Drinking Water Audit Report

| Plant(s) visited: | Shrone 1300PUB1121 | Date of issue of Audit Report: | 10/10/2014 |
| | | File Reference: | DW2007/477 |

Photograph 1: Turbidity monitor; there is one turbidity monitor which alternates between the two active filters every five minutes.

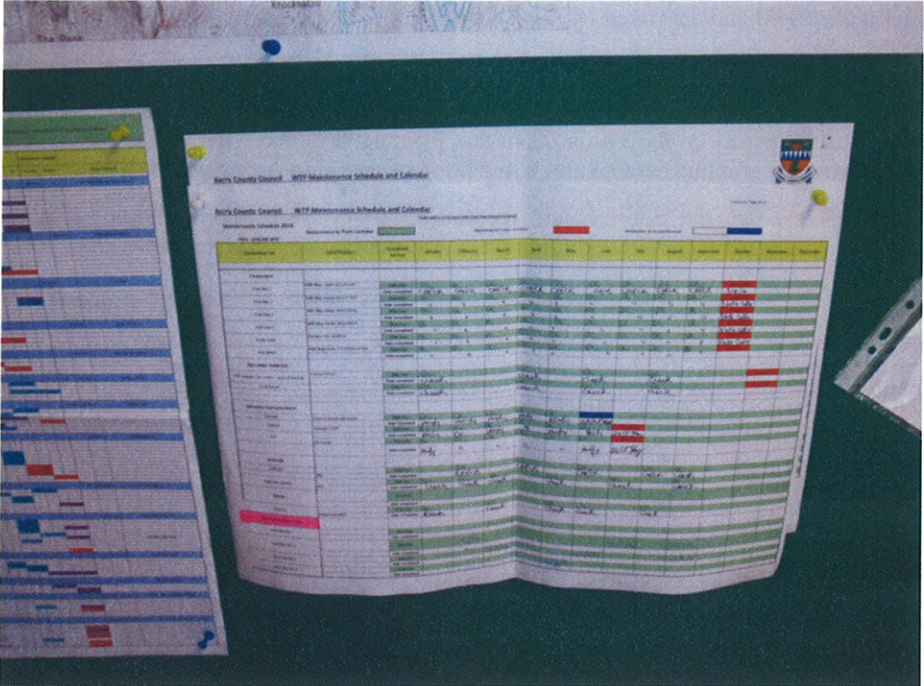
| 2. | <p>Filtration</p> <ul style="list-style-type: none"> a. Filtration at this plant consists of four slow sand filters, with two filters in operation at any one time. At the time of the audit filters No 3 and No 4 were operational. According to KCC each filter is cleaned every 2-3 months, cleaning is scheduled based on head loss of the filter and not on turbidity. b. Water from the filters which are not in use is run to waste. The standby filters are brought straight back into service when required. c. KCC stated that the design and the actual flow through each filter is 18 m³/hr and 7- 8 m³/hr respectively. The surface area of each filter is 81 m². d. KCC confirmed that the depth of the sand was 1m; and that the effective size of the sand was 0.36 mm. e. There is one turbidity monitor after the filters, (see photograph 1). This monitor automatically alternates reading between each filter every five minutes, and according to KCC it takes approximately one minute after alternating for the monitor to adjust fully to the correct reading. It is indicated on SCADA which filter is being monitored at any one time. |

| | <ul style="list-style-type: none"> f. The reading on the turbidity monitor at the time of the audit was 0.153 NTU. KCC stated that there was no alarm on this monitor. This monitor was last calibrated on the 24/07/2014. g. Two months turbidity results in graph form from the filters were observed; the results showed the turbidity levels from filters No. 2 and No. 3, the results were at a consistently low level, at approximately 0.3 NTU. h. There was a filter log book on site which clearly documented the maintenance of the filters. Daily turbidity monitoring results after each filter were also documented. |

There is no alarm on the turbidity monitor after the filters. Irish Water must ensure that all turbidity monitors have dial out alarms in place. Alarms levels should be set so as to give the caretaker/staff adequate time to respond to appropriately.

2. The Water Services Authority should install a dial out alarm on the turbidity monitor after the filters. The alarm levels should be set to alert staff to any deviation from the acceptable operating range of the filters.
